Product Change Notification: PCN-24-229901

EPII Contact Terminal

Product Change Notification: PCN-24-229901

EPII Contact Terminal

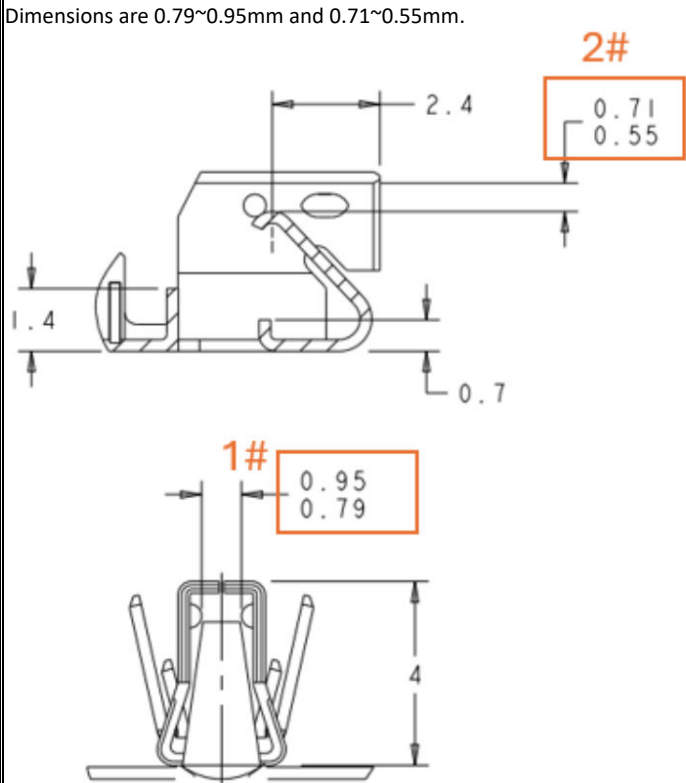
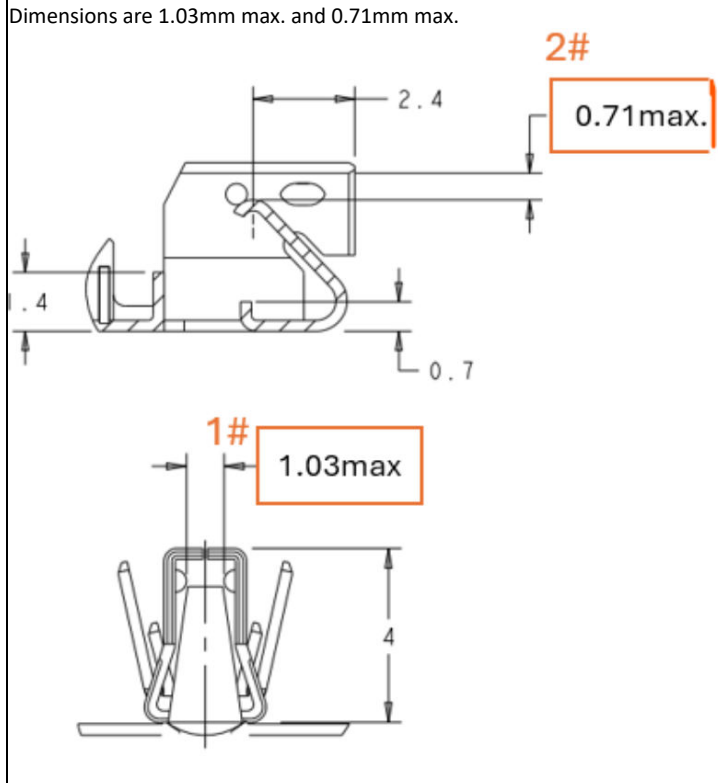
Please be aware the listed documents have been updated to make a correction (not affecting specification of product). Before: 0.79~0.95mm and 0.71~0.55mm. After: 1.03mm max. and 0.71mm max.

Dimensions are 0.79~0.95mm and 0.71~0.55mm.

Dimensions are 1.03mm max. and 0.71mm max.

Update made to correct a documentation error, to align with the production part.
